FCC Permissive Change 1 Application Letter

FCC ID: R7C-F100

Class II Change: modification of antenna for 850MHz performance.

Mechanical differences between M30 and M35 Antenna Design:

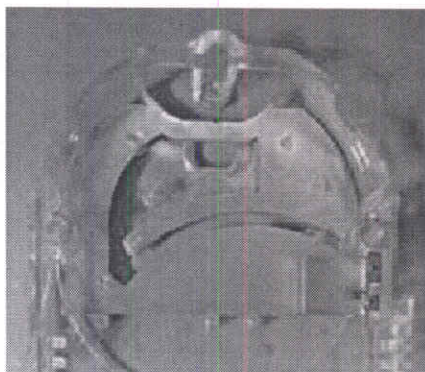
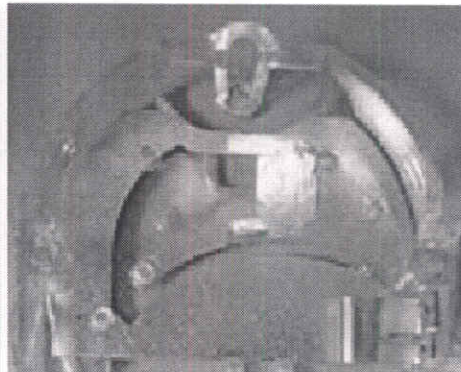
Pictured below is the M30 (left) and M35 (right) antenna. The only difference is the addition of 1.4 mm of material to the vertical slot below. This affects the GSM 850 response only. See Firefly Antenna Differences M30 M35 PCS for details.
